FORM APPROVED
OMB NO. 1004-0137
Expires: January 31, 2018**SUNDRY NOTICES AND REPORTS ON WELLS**
*Do not use this form for proposals to drill or to re-enter an abandoned well. Use form 3160-3 (APD) for such proposals.*5. Lease Serial No.
NMNM2379

2. Name of Operator
OXY USA INCORPORATEDContact: DAVID STEWART
E-Mail: david_stewart@oxy.com8. Well Name and No.
COVINGTON A FEDERAL 169. API Well No.
30-025-33224-00-S13a. Address
P O BOX 4294
HOUSTON, TX 77210-42943b. Phone No. (include area code)
Ph: 432-685-571710. Field and Pool or Exploratory Area
RED TANK

OXY USA Inc. - Current
Covington A Federal #16
API No. 30-025-33224

Permanent Abandonment of Federal Wells
Conditions of Approval (LPC Habitat)

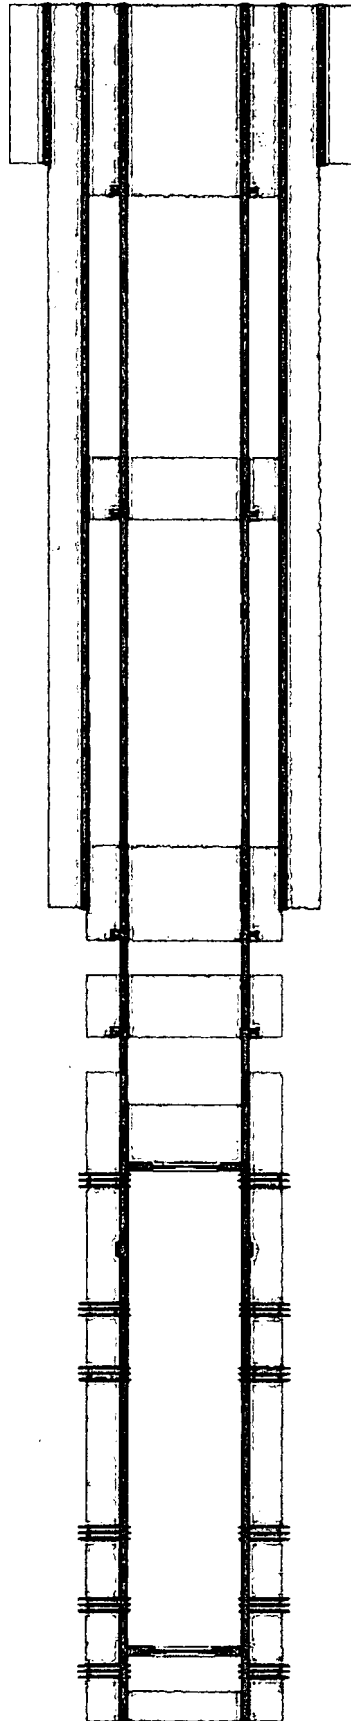
SEE ATTACHED FOR
CONDITIONS OF APPROVALRIH Tag, CIBP @ 8800. Spot 25
5x class # to 8696. (T/BS) Tag.
Spot plug from 6738-6558. WOC Tag
(DVT) Can set CIBP
@ 6738 and spot
25 5x. TagBelow ground level dry hole marker required
